**QUEANBEYAN-PALERANG REGIONAL COUNCIL
ORDINARY MEETING OF COUNCIL**

Item 9.2	DA.2023.0461 - Proposed Co-living Housing Development - 95 Crawford Street, Queanbeyan	
Attachment 1	Proposal Plans - DA.2023.0461 - 95 Crawford Street Queanbeyan.....	2
Attachment 2	Draft Conditions of Consent - DA.2023.0461 - 95 Crawford Street Queanbeyan.....	17
Attachment 3	Submission - DA.2023.0461 - 95 Crawford Street Queanbeyan.....	37
Attachment 4	Clause 4.6 Variation request - DA.2023.0461 - 95 Crawford Street Queanbeyan.....	39
Attachment 5	Operational Plan of Management - DA.2023.0461 - 95 Crawford Street Queanbeyan	61
Attachment 6	Section 4.15 Assessment - DA.2023.0461 - 95 Crawford Street Queanbeyan.....	68
Attachment 7	Supplementary Report - DA.2023.0461 - Response to issues raised at 23 October 2024 meeting.....	93

ITEM 9.2 DA.2023.0461 - PROPOSED CO-LIVING HOUSING
DEVELOPMENT - 95 CRAWFORD STREET,
QUEANBEYAN

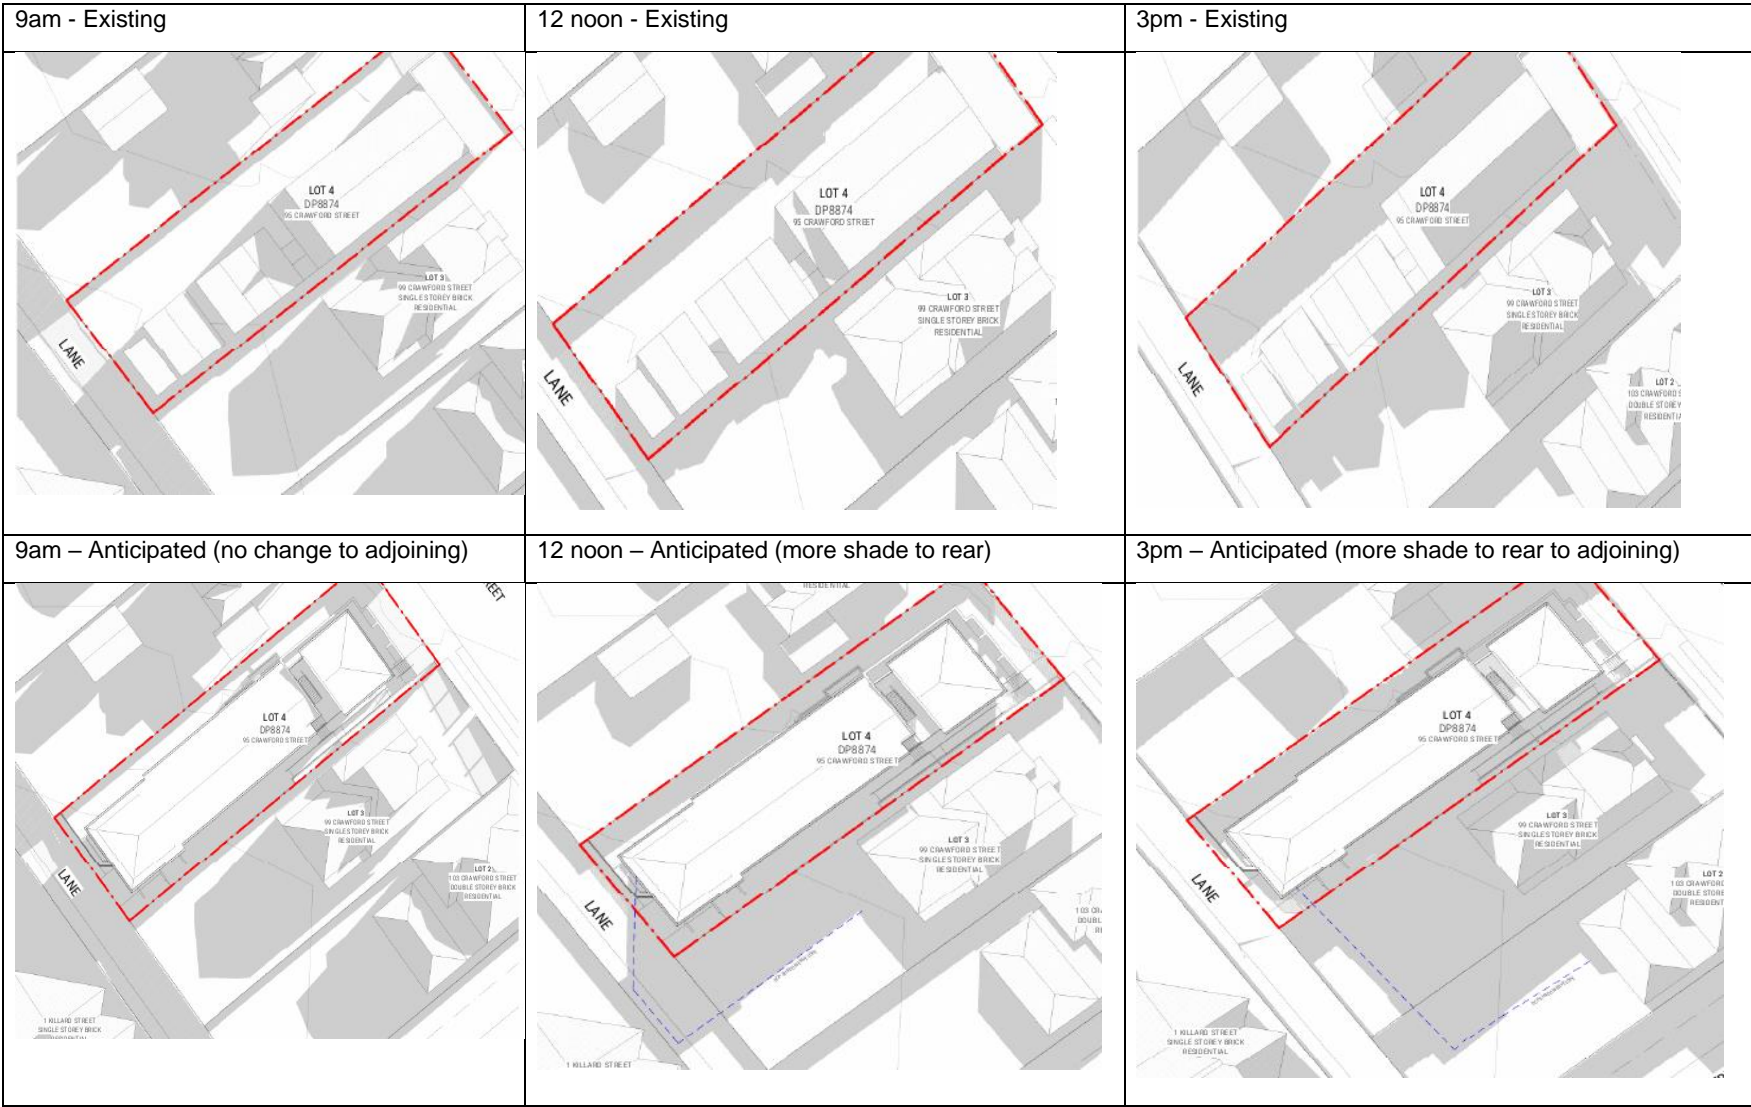
According to the Survey Plan submitted with this application, the subject site adjoins land to the south that accommodates a brick building (dwelling) which is setback approximately 1.2m. Separation between the buildings at 4.4m is provided.

The applicant has argued that the proposed development meets the aims of the Apartment Design Guide including with the reduced setbacks. At between 3.2 – 4.4m the setback to the southern side property boundary achieves an appropriate level of residential amenity including visual and acoustic privacy, natural ventilation, sunlight and solar access are maintained including to the adjoining site.

Detail of plan DA101 – Retaining wall currently 2.5m to boundary

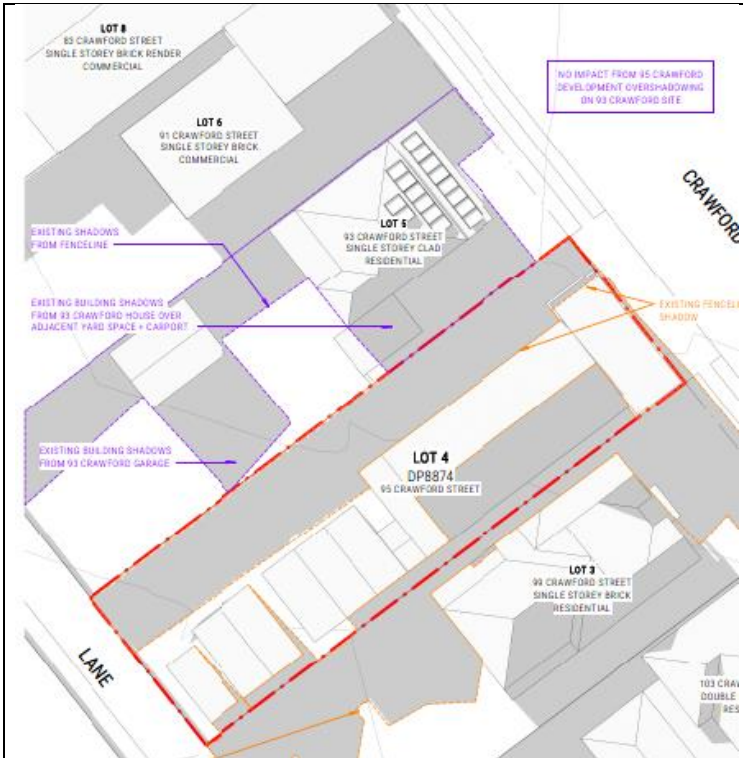
There is an existing pine tree on the adjoining land to the north, near the property boundary. The submitter is seeking to ensure the tree remains viable.

Currently the retaining wall to the development at 95 Crawford Street is proposed to be setback 2.53m from the side boundary.

The applicant has offered to increase the setback to 3.5m to the trunk of the tree to limit any potential disturbance to the root zone. A tree management plan with measures to protect the tree on the adjoining site can also be sought as a condition.

3pm – 21 June – Existing Shadow

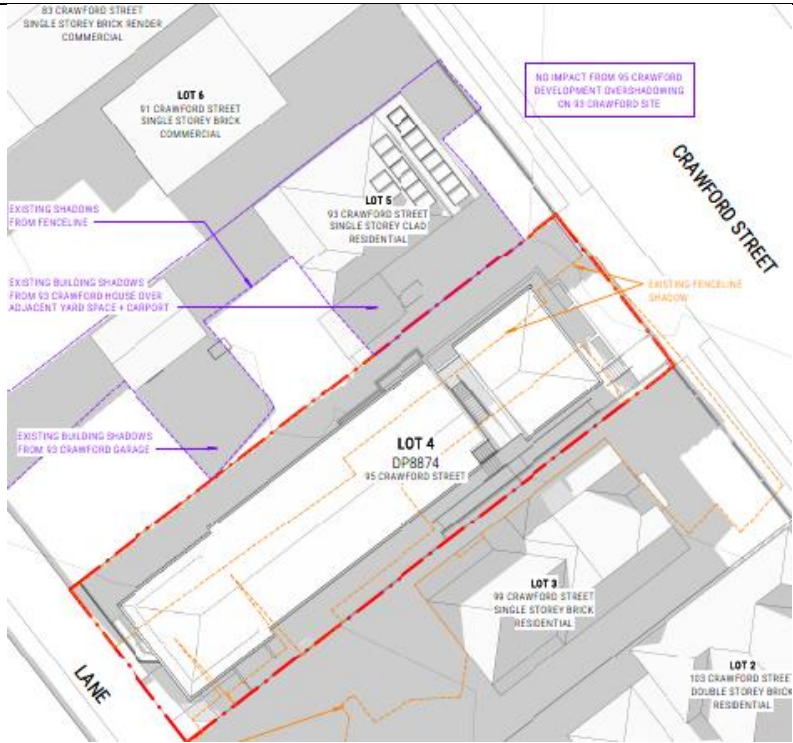
Attachment - Shadow impacts to garage roof on adjoining property – 9am, 12 noon and 3pm – existing and proposed.
